Re: Feasibility Study Addendum
2350 Fifth Avenue, New York, NY
NYSDEC Site #231004

Response to Comments

Comments to the *Draft Feasibility Study* consisted of NYSDEC correspondence dated September 1, 2010, and emails from NYSDEC on September 20 and 23, 2010. NYSDEC requested this FS Addendum be prepared rather than reissuing the full FS. As such, we are addressing the comments in this addendum to the extent possible following each comment. The following comments were provided in a September 1, 2010 letter from NYSDEC:

2350 FIFTH AVENUE, NEW YORK, NY
SUB-SLAB INSULATION MATERIAL -
PCE CONCENTRATIONS

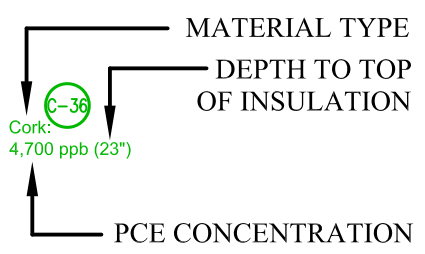
- 5. Section 5.6 indicates that the preferred alternative is Alternative 4, which consists of in-situ soil and groundwater treatment including an SVE system to address soil and an SSDS to address soil vapor and insulation material. The Department disagrees, and recommends that source removal to the extent practical, including excavation and off-site disposal of the contaminated soil and insulation material, be included in the selected remedy.*

- 6. The department is considering the proposed treatment option plus the removal of the insulation material to the extent practical.*

This FS Addendum revises Alternative 4, and specifically I2, to include partial removal of sub-slab insulation in a maximum 1,200-square foot area, to the extent practicable, in the northwestern portion of the site, as shown on the attached Revised Figure 4.

As discussed in a meeting with NYSDEC on December 1, 2010, the maximum removal area encompasses the area with the highest PCE concentrations detected in the insulation material, as shown on the attached Revised Figure 4. As the sub-slab insulation material is different from a traditional soil matrix, based upon different physical properties and being isolated with a concrete slab both above and beneath the material, the NYSDEC Soil Cleanup Objectives are not applicable. The removal of contaminated insulation from this area would result in contaminant mass reduction for this media in excess of 90%. A table summarizing the mass calculations is provided in Appendix C.

During remedial design, additional insulation sampling would be completed to confirm the presence of insulation within the targeted area shown on Revised Figure 4 and confirmatory samples would be collected for laboratory analysis. The targeted removal area could be reduced in consultation with DEC based on this additional sampling. A structural engineer would be consulted to confirm potential demolition areas and protection of the existing building. Plumbing and electrical trades would be consulted for evaluating and disconnecting existing utilities in the removal area. If the sampling identifies significantly lower concentrations than those identified as part of the FS or significant limitations are identified due to structural concerns, utility conflicts, or other considerations, the targeted area for insulation removal may be reduced.
